STATE OF MAINE
DEPARTMENT OF TRANSPORTATION
16 STATE HOUSE STATION
AUGUSTA, MAINE
04333-0016

September 13, 2006
Subject: **South Portland**
Project No. STP-8822(00)X
Pin No. 8822.00
Amendment No. 2

South Portland
STP-8822(00)X
Western Avenue
September 13, 2006

6,000 Gallon Heavy Duty Tank

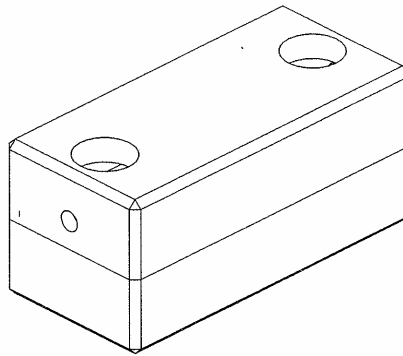
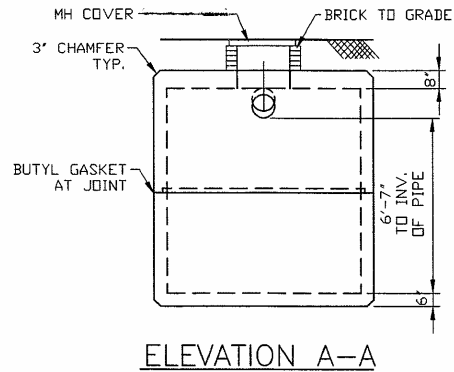
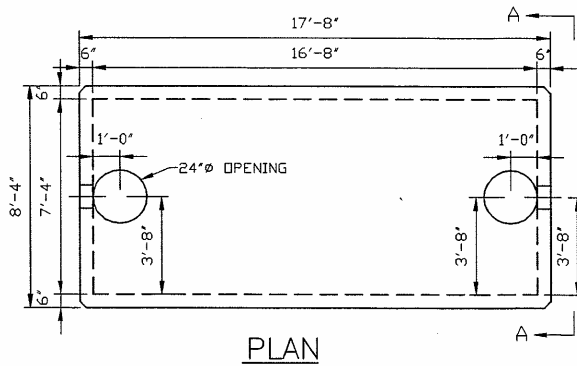
In the book under "Special Provision, Section 604, Precast Concrete Tank" two pages total, delete the page 2 of 2 drawing dated August 14, 2006 and replace with the attached updated page 2 of 2 drawing dated September 13, 2006.

Design Parameters:

Live load: HS20
Earth Cover: As required
Concrete: Design strength $f_c = 5000$ psi
Reinforcing: ASTM A615 (Rebar) Grade 60
ASTM A185 (WWF) $f_y = 60,000$ psi
